**PLAN COMMISSION
MEETING NOTICE AND AGENDA
Thursday, September 17, 2020
7:00 PM**

REPORT TO THE PLAN COMMISSION

Briohn Building, on behalf of the applicant Laurie Stollenwerk, submitted a Certified Survey Map and Site & Building Plans for a proposed multi-tenant industrial speculative building for property located at approximately N17W25045 Bluemound Road (Tax Key Nos. 0948985003 and 0945989001).

Discussion and Action Regarding the Site and Building Plans for a Proposed 218,000 Square Foot Multi-Tenant Building for the Pewaukee 16-94 South Industrial Development Located at N17 W25045 Bluemound Road (PWC 0948985003 & PWC 0945989001)

1 OVERALL FIRST FLOOR PLAN
1" = 30'-0"

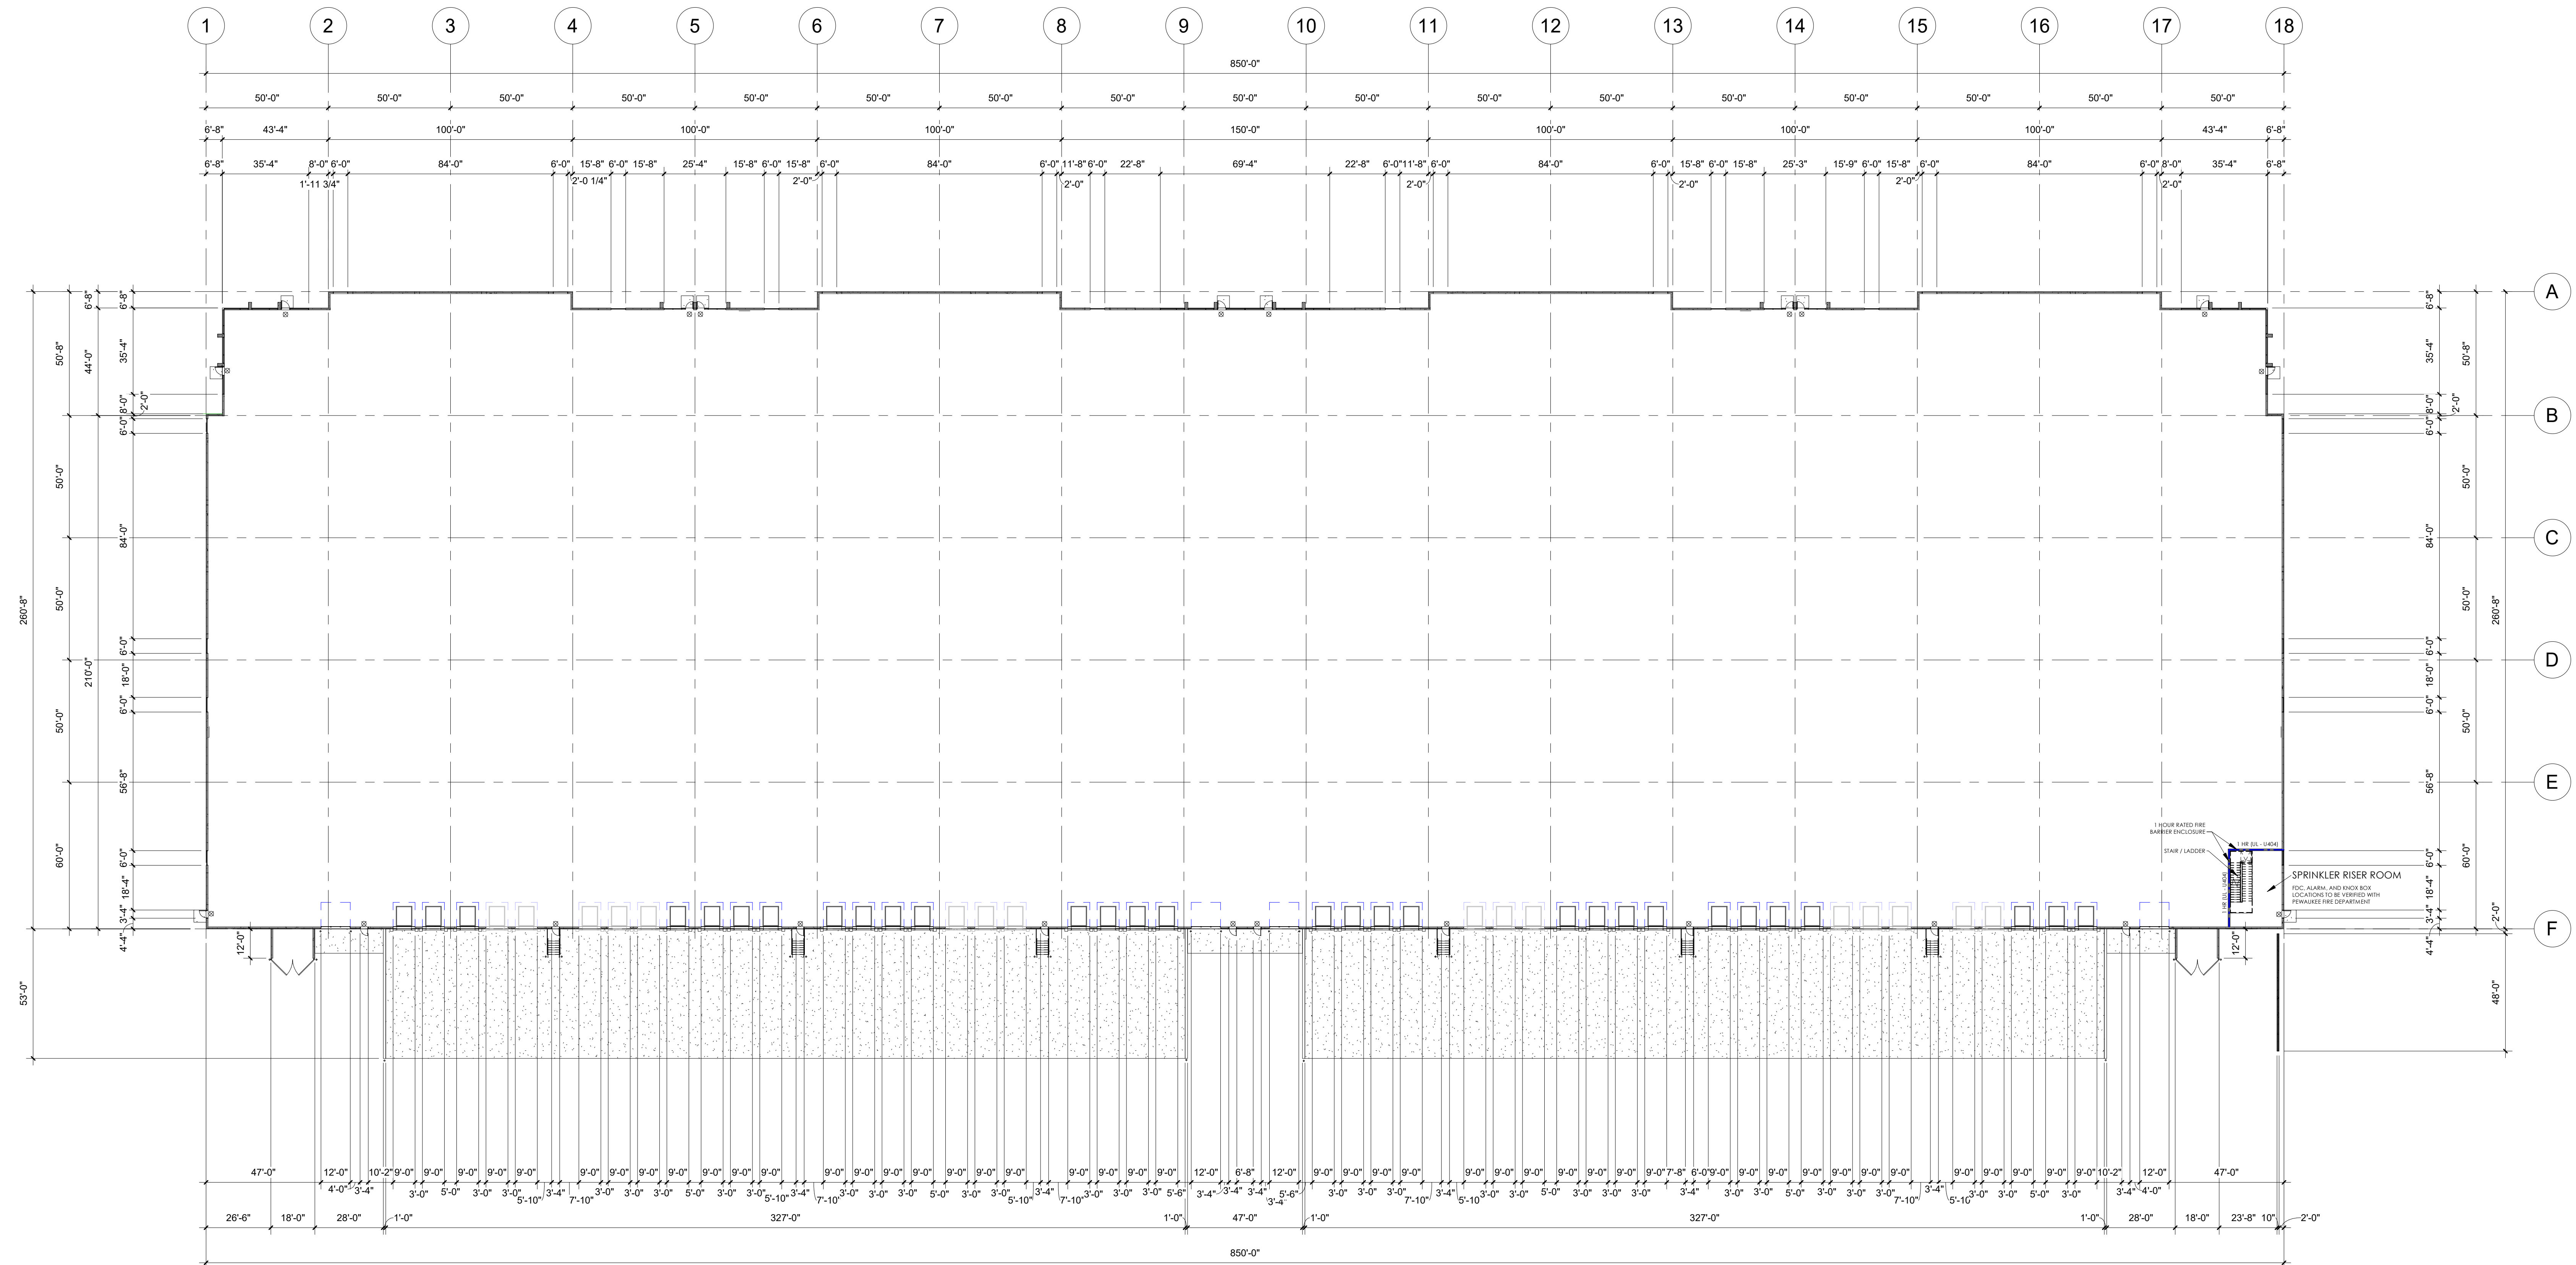
A rooftop mechanical plan was provided (Sheet A4.1), which illustrates mechanicals centered behind parapet walls. According to the applicant, mechanicals will not be visible from any public right-of-

way. Staff recommends that if rooftop mechanicals are visible from public rights-of-way (Bluemound Road, Highway 16, and I-94), the applicant shall install rooftop screening as approved by the City Planner.

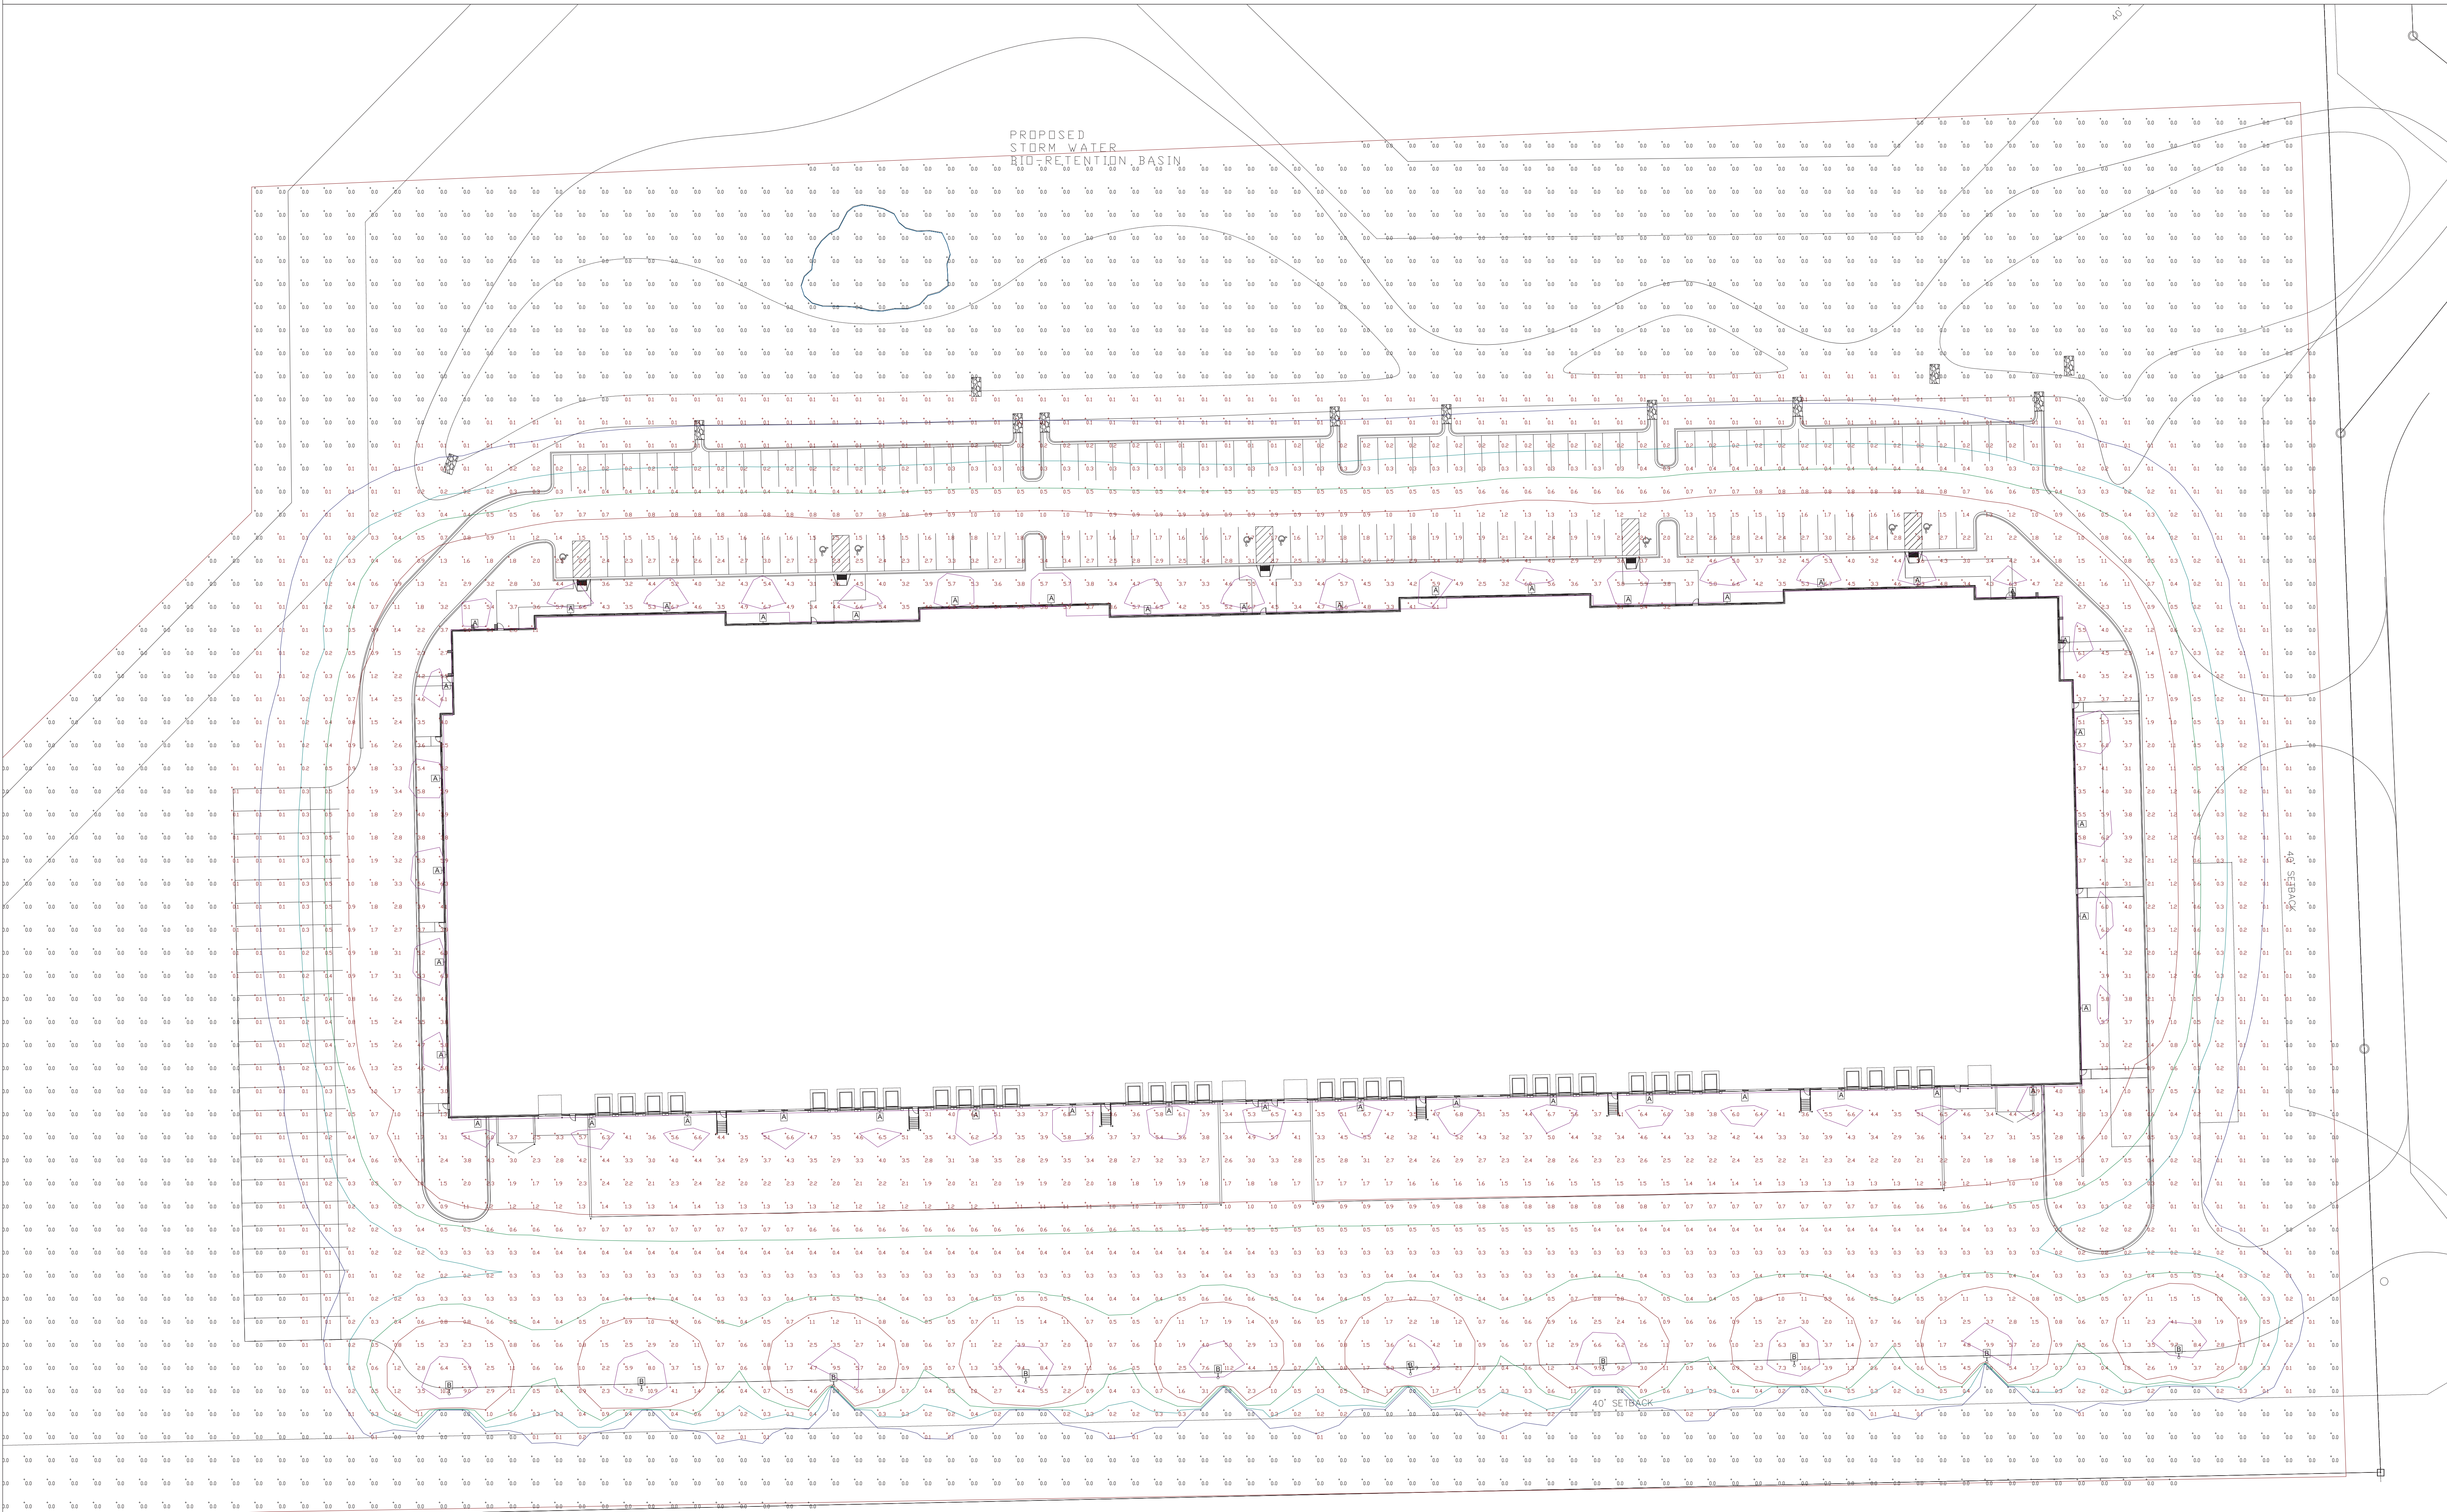
The Lighting Plan consists of parking lot and building lighting. Light levels are at 0.0 footcandles at the property lines. The peak height of lights is 17-feet, which complies with the 20-foot maximum height requirement of the Zoning Code.
